License to Operate On-Site Sewage Treatment and Disposal Facility

Issued This Date: **08/01/2024** Permit Number: **115790**

Location Description: 6790 RIVER RD
NEW BRAUNFELS, TX 78132

Type of System: Aerobic
Drip Irrigation

SITE PLAN & OSSF DESIGN

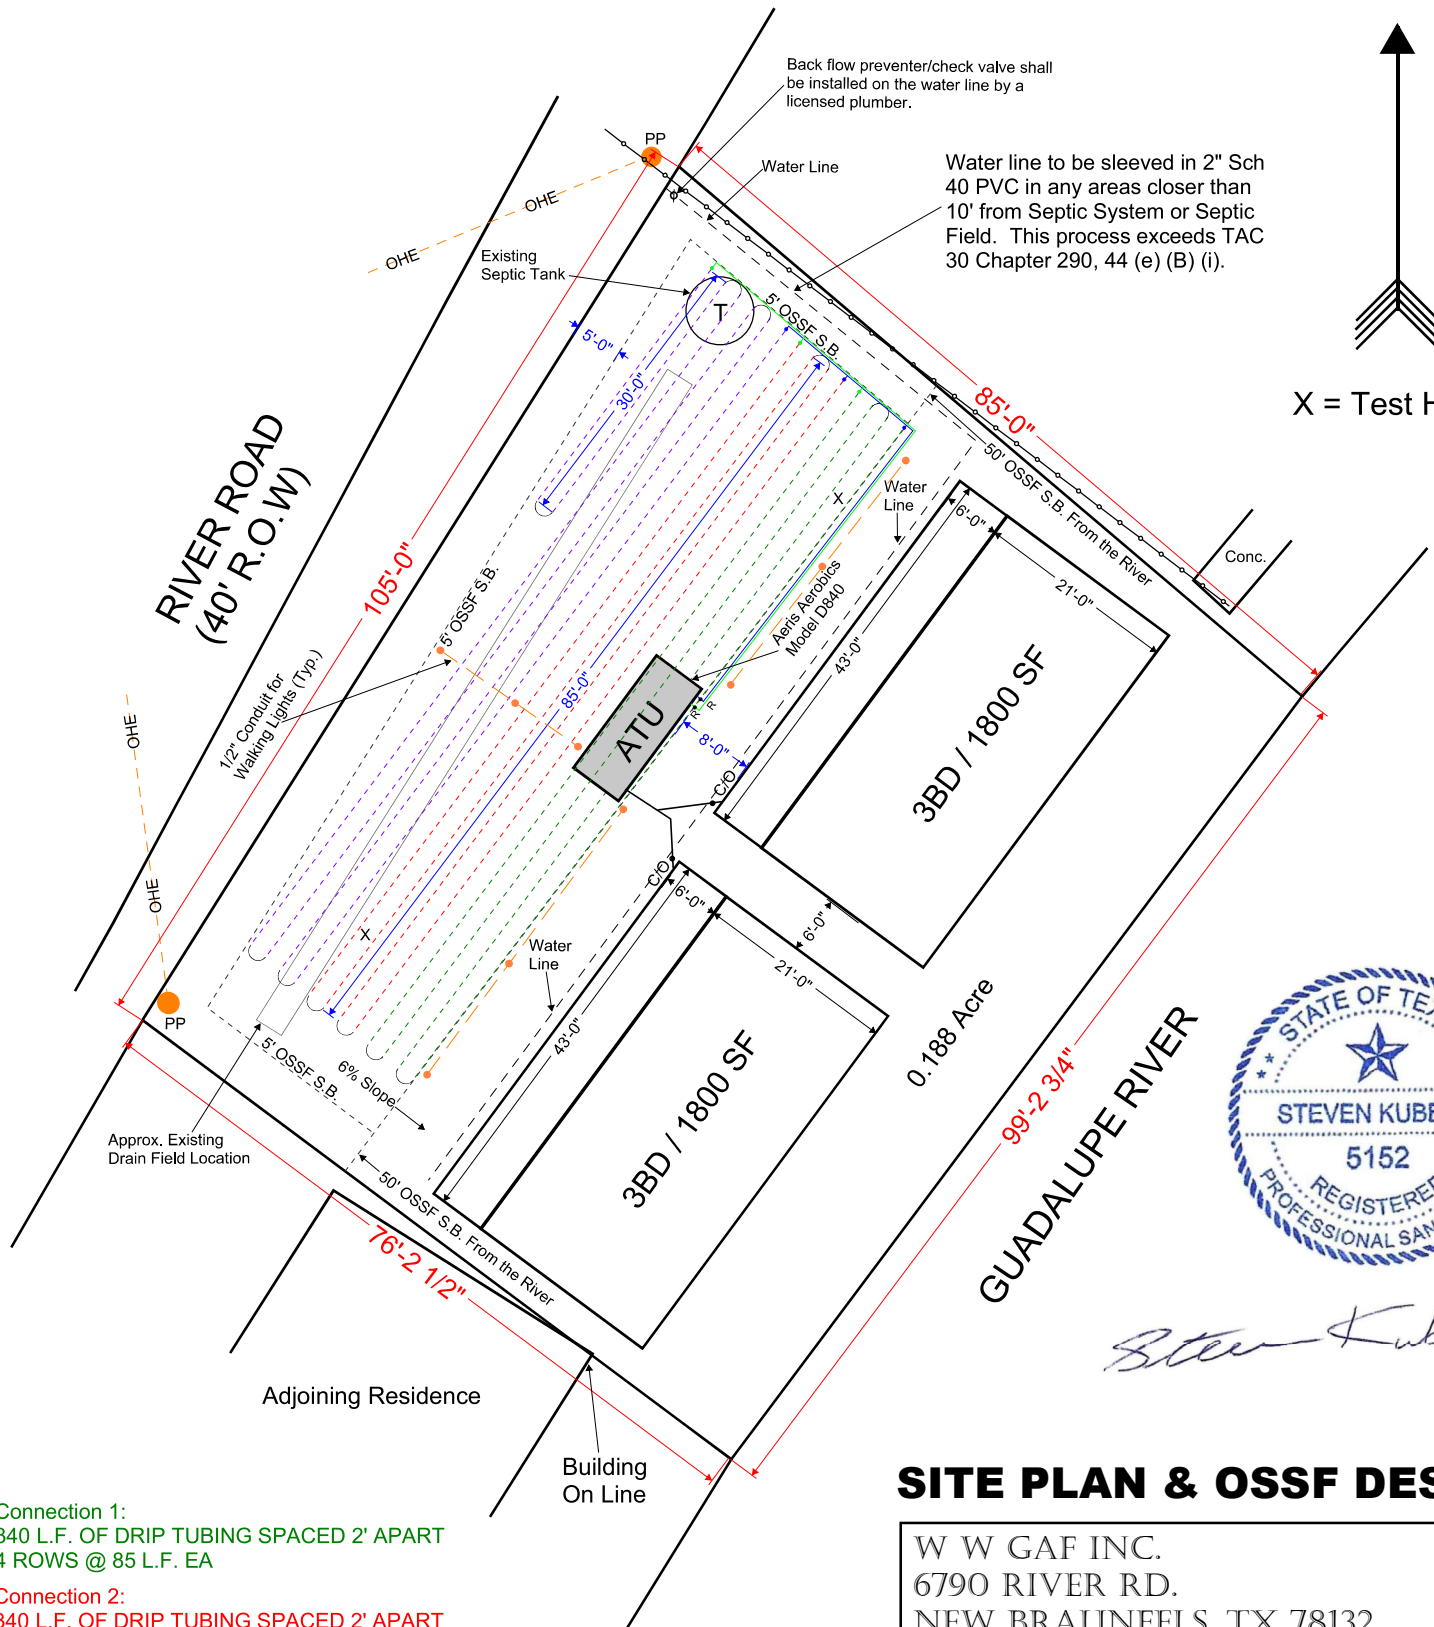
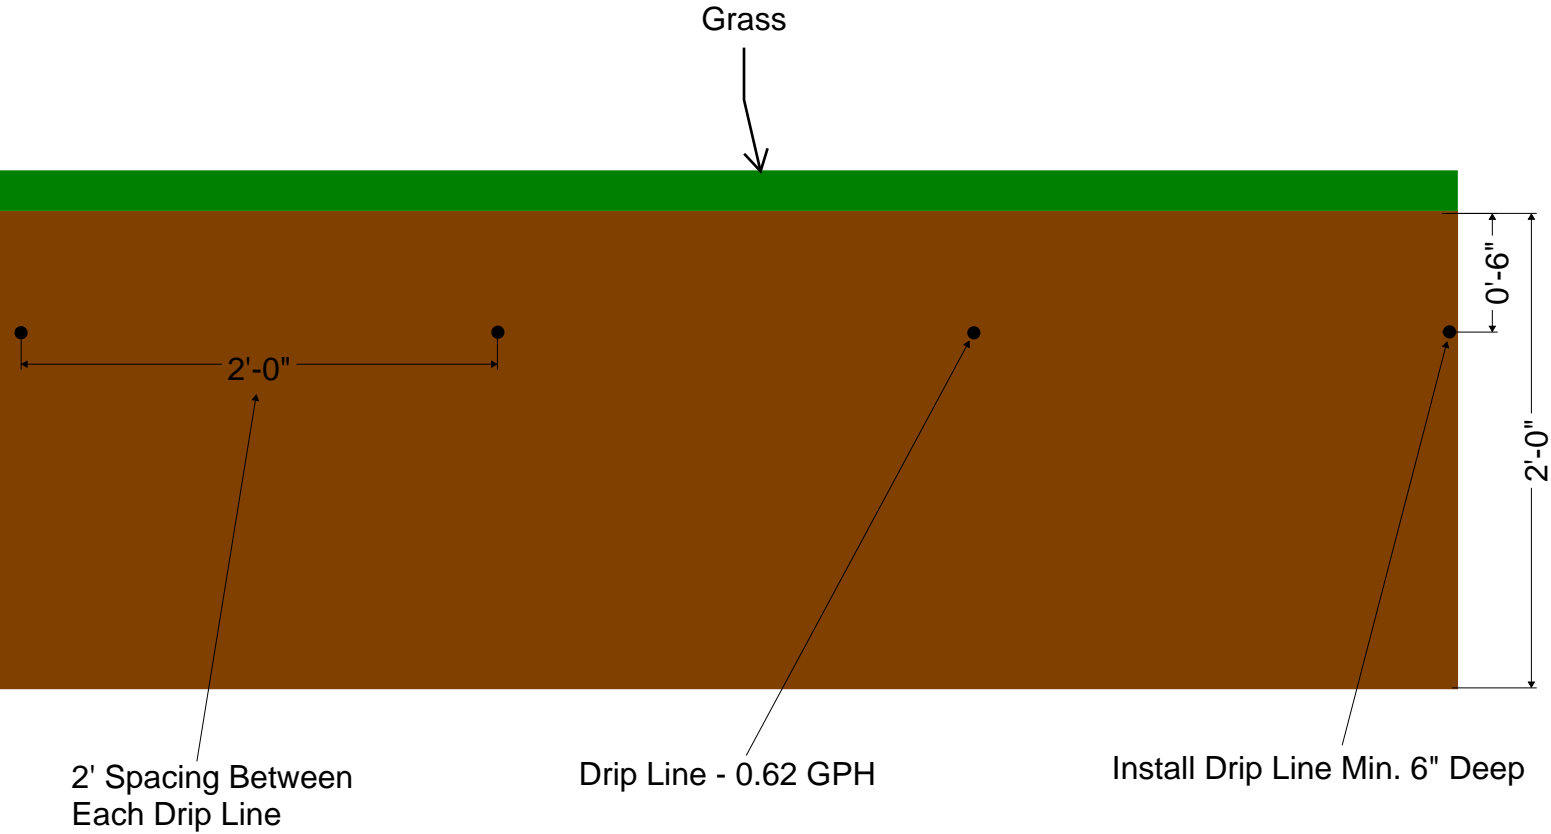
We'd like to clarify the design for the lights planned for the drip field area.

1. Will there be a designated walking path installed (such as gravel or concrete) alongside them?
2. We're concerned about future maintenance access to the electrical lines for these lights. Any work done in the disposal area may require a new OSSF permit.

Where is the parking for these structures?

property line. Lights installed across field and outlining field. Needs operational after replacing loops.

4/23/24 JC Operational, cover. Needs back flow prevention valve at inlet

5/15/24 JC unable to confirm back flow prevention valve. Need pump and crush doc. Not sodded, used curlex with seed. Need bouyancy calculations for tank. Tanks were not strapped.

1. No, there will not be a permanent walking path, this is just to light the way through the grass.
2. There is conduit and junction boxes run to each light, new wire can be pulled without the need to excavate.

- Across the street, Zandra mentioned she sent in documentation on this.
